Addendum No. 1
OLD WASHOE 4 WELL
PWP No.: WA-2016-064
TMWA Project No.: 15-0031

January 14, 2016

The following information, clarifications, changes and modifications are by reference incorporated into the bid documents for the above referenced project. Any work item or contract provision not changed or modified will remain in full force and effect. The bid date and time and construction schedule remain the same.

DRAWING NUMBER
S-2
 SHEET
 19 OF 29

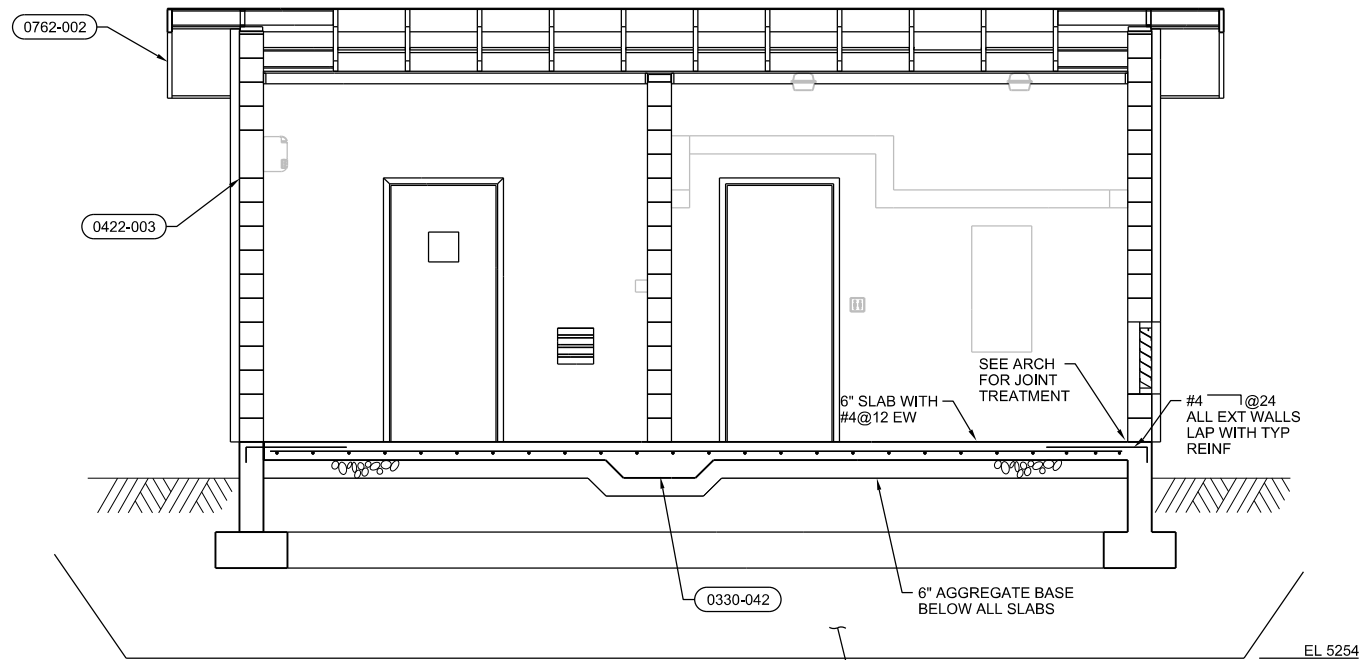
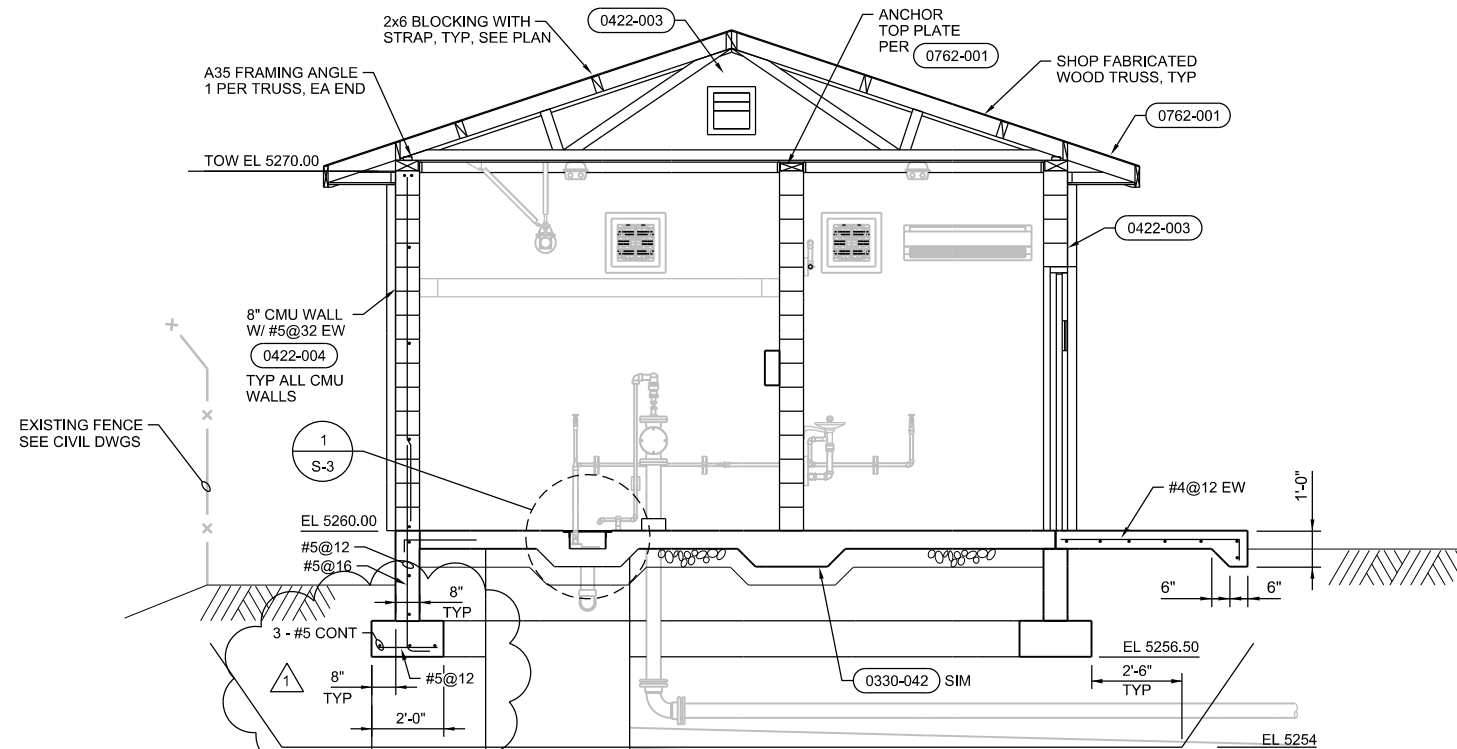
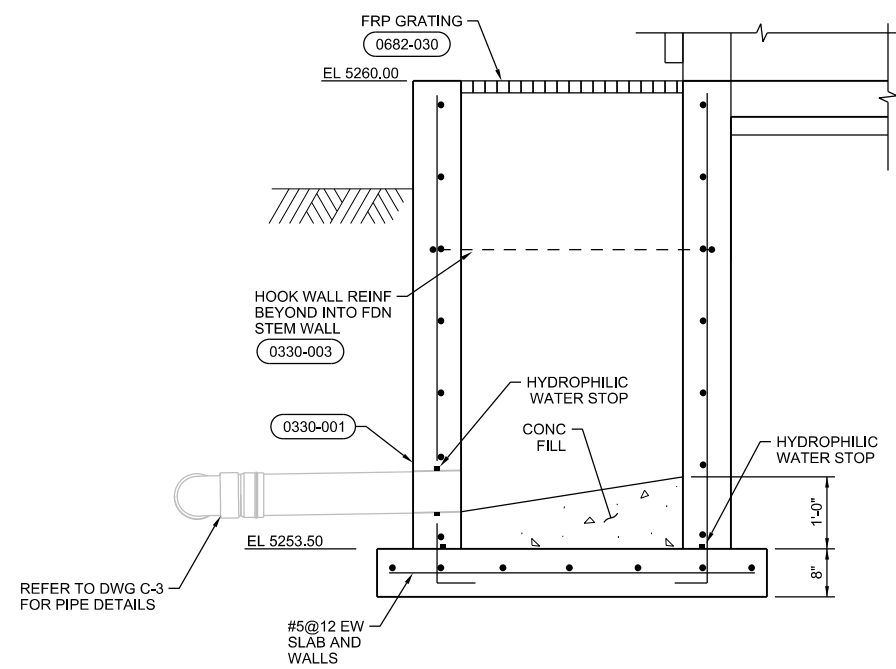
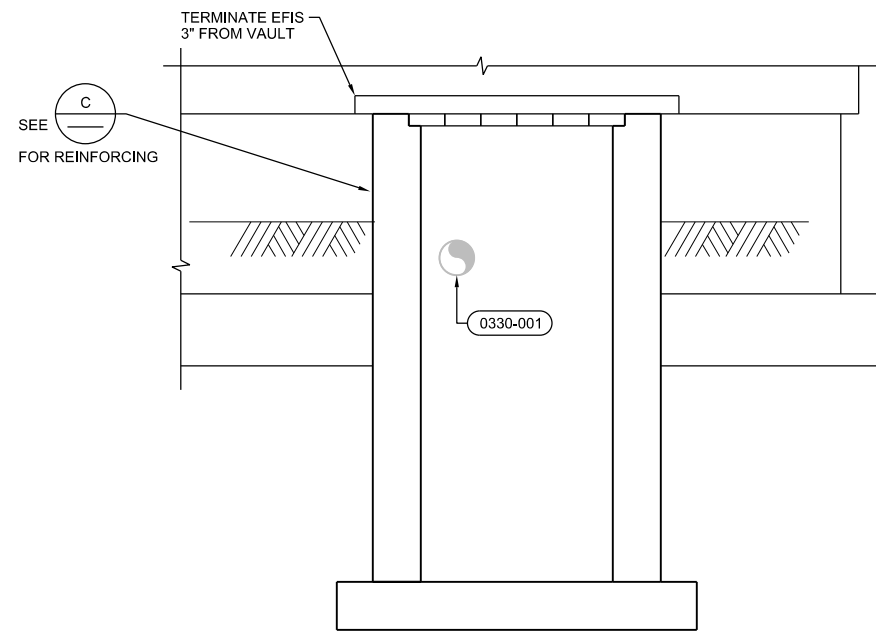
Question No. 4: Sheet S-2, Detail A, calls for ‘OVER EXCAVATE IN ACCORDANCE WITH SECTION 31 23 16, EXCAVATION, TYP’. In the soils report prepared by Wood Rodgers, Section 7.4 ‘Grading and Filling’ it states “overexcavation and replacement to prepare the building pad is therefore not required” as it is adequately compacted, previously stated in same sentence. What will be required?

Response to Question No. 4: Over excavation and placement of structural fill will be required as depicted in Drawing S-2. Please reference Article 2.11 in the contract General Conditions regarding geotechnical reports made available and interpretations of any conclusions contained within.
